TRANSMITTAL

Project Description: Replacement Senior Citizen Center Construction

RE: Change Order #40 **fully executed**

**LEXINGTON-FAYETTE URBAN COUNTY  
GOVERNMENT CONTRACT CHANGE ORDER**

**SKA-126**

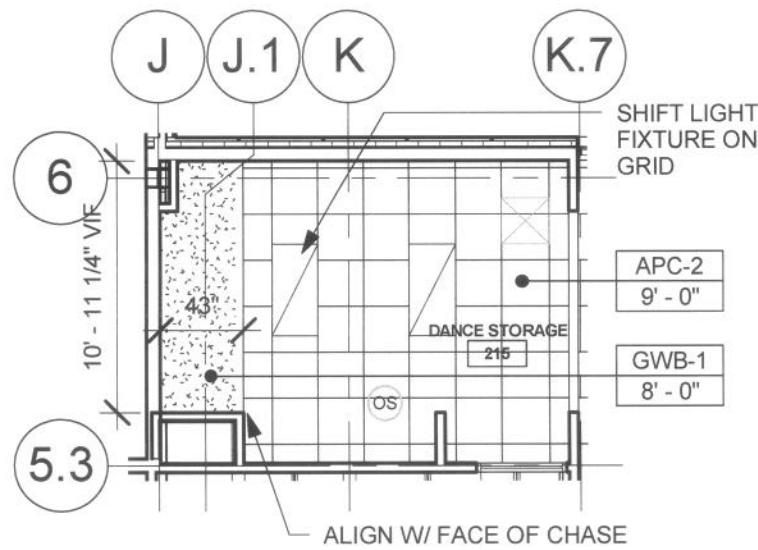
1. Necessity for change: Designed ceiling height conflicts with HVAC ductwork in Dance Storage. Adding a soffit will conceal the ductwork. Flooring installer recommended adding the passive air grilles and underlayment to increase air circulation under the floor and to protect the wood flooring. Plywood is more resilient than drywall and is more appropriate for an exterior storage space.

To avoid conflict with HVAC ductwork, please furnish a painted GWB soffit per the attached sketch. Please verify all dimensions prior to fabrication.

1 **DANCE STORAGE CEILING**  
 SKA-126 SCALE: 1/4" = 1'-0"

2 **PARTIAL 2ND FLOOR RCP**  
 SKA-126 SCALE: 1/8" = 1'-0"

**SKA-127**

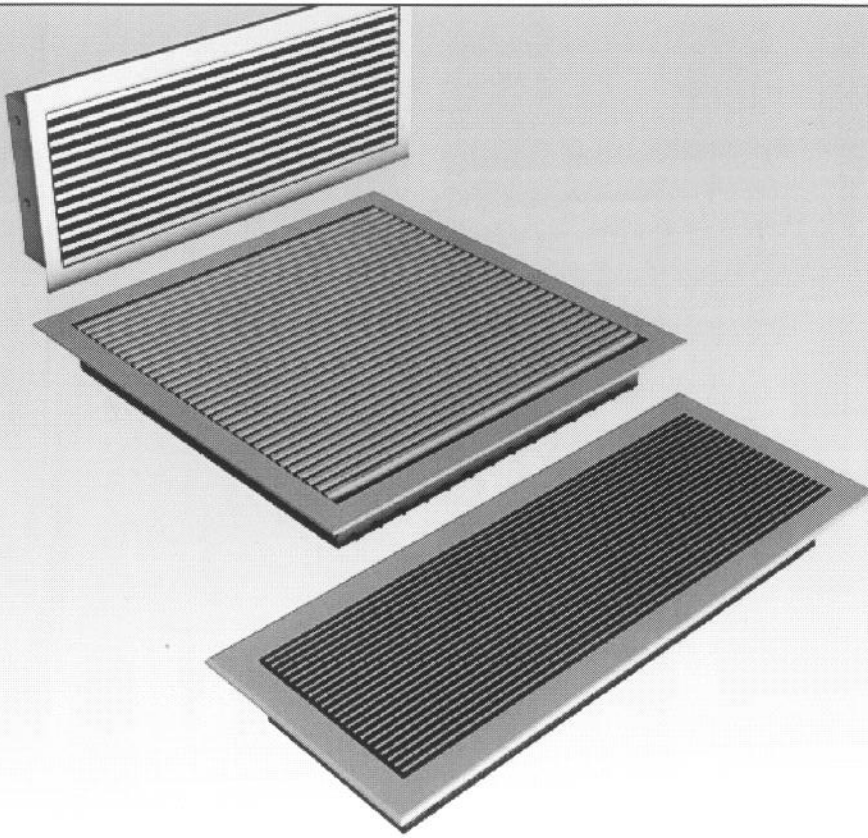
Per recommendation from the flooring subcontractor, please furnish and install the following improvements for the platform flooring:

- Lay 20 mil minimum plastic nonwoven membrane sheet at the floor slab to inhibit moisture infiltration into the plenum
- Install (2) displacement floor grilles as shown on the attached sketch for adequate air movement in the plenum. See basis-of-design product data in attached documents. Install blocking as required to adequately support floor grilles for normal traffic. Install between floor support studs; do not cut floor support studs to install (dimensions on the attached sketch are suggestions; locate as near

1 CA-FLOOR GRILLES AT PLATFORM  
 SKA-127 SCALE: 1/8" = 1'-0"

DISPLACEMENT FLOOR GRILLE, TYP  
 -INSTALL PER MANUFACTURER'S INSTRUCTIONS  
 -WOOD BLOCKING AS REQUIRED TO MATCH ROUGH OPENING BETWEEN FLOOR SUPPORTS  
 -FIN LAYOUT AND FINISH PER SPEC SHEET
